#35/13-07 HH Chevy Chase Village H.D.
4 Oxford Street, Chevy Chase

MEMORANDUM

SUBJECT: Historic Area Work Permit #439239 (**Revision**), Driveway and walkway replacement, and alterations

Address:	4 Oxford St, Chevy Chase	Meeting Date:	9/11/2007
Resource:	Contributing Resource Chevy Chase Village Historic District	Report Date:	9/4/2007
Applicant:	Mary & Porter Wheeler (Steven Vance, Architect)	Public Notice:	8/28/2007
Review:	HAWP (REVISION)	Tax Credit:	None
Case Number:	35/13-07HH	Staff:	Josh Silver
PROPOSAL:	Driveway and walkway replacement, and alterations

B2
ASD19A
PROPOSED SITE ELEVATION
1/8" = 1'-0"

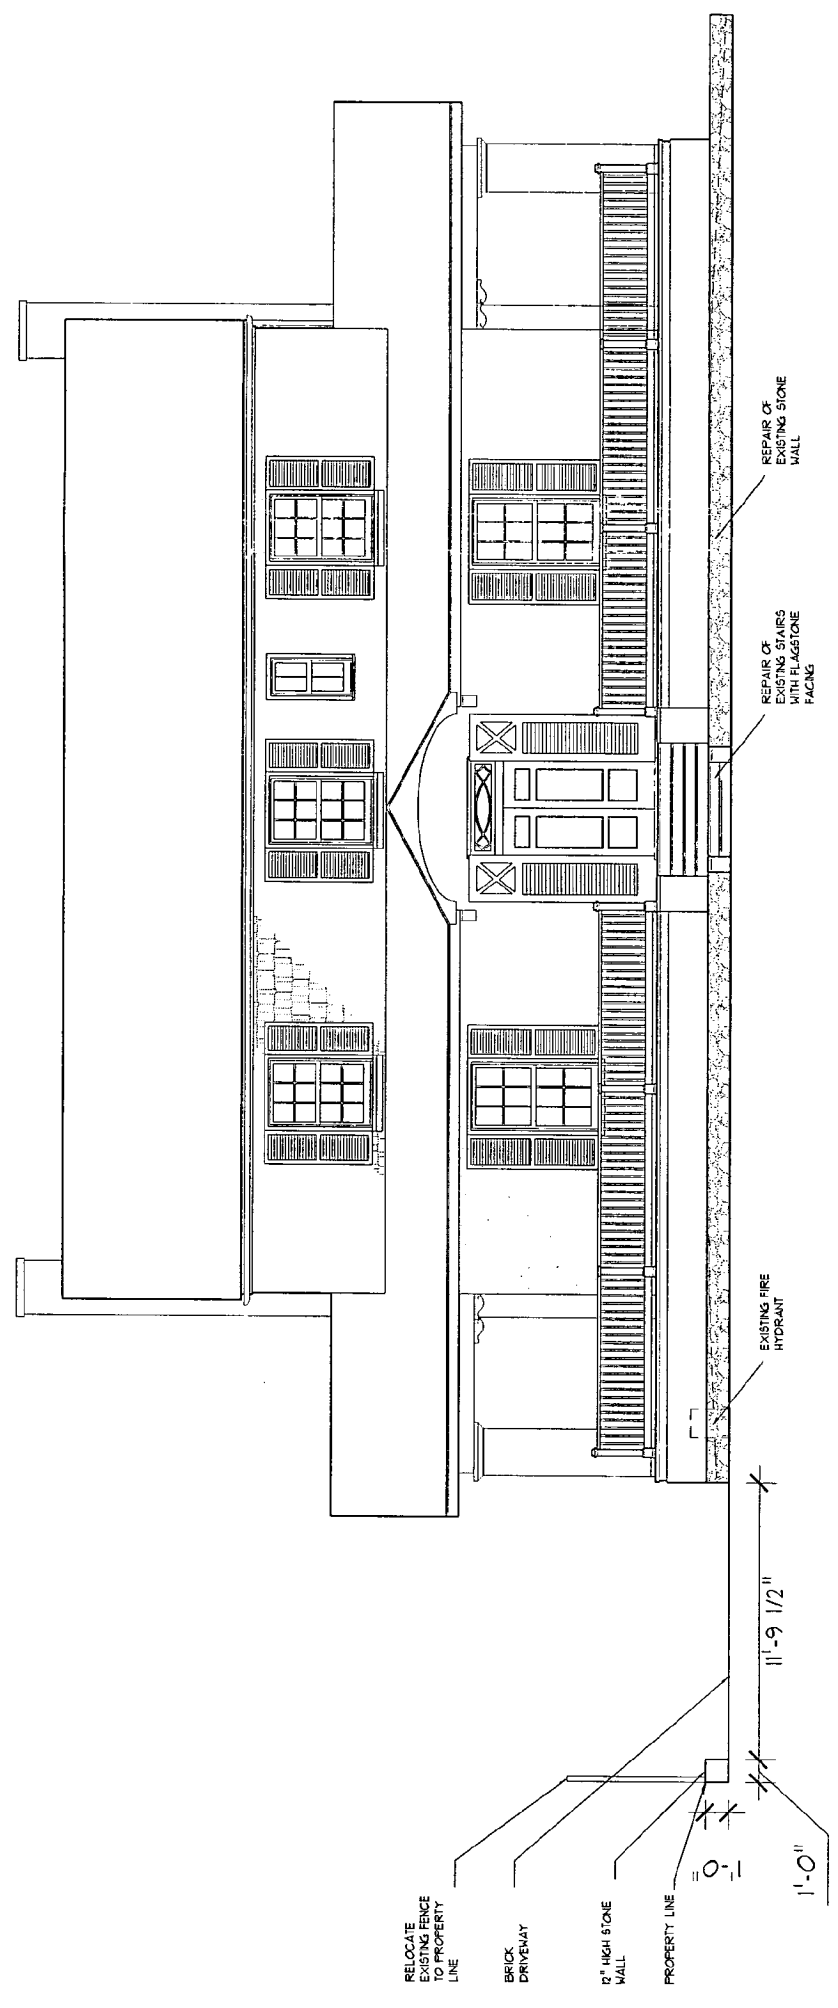
1. *The applicant will contact the Chevy Chase Village arborist to determine if a tree plan is necessary for the project. If required, the tree protection plan must be implemented prior to beginning the project.*
2. *The proposed trash container enclosure will not be higher than 4'5". (Detail to be shown on permit set of drawings).*

1. The applicant will contact the Chevy Chase Village arborist to determine if a tree plan is necessary for the project. If required, the tree protection plan must be implemented prior to beginning the project.
2. The proposed trash container enclosure will not be higher than 4'. (Detail to be shown on permit set of drawings).
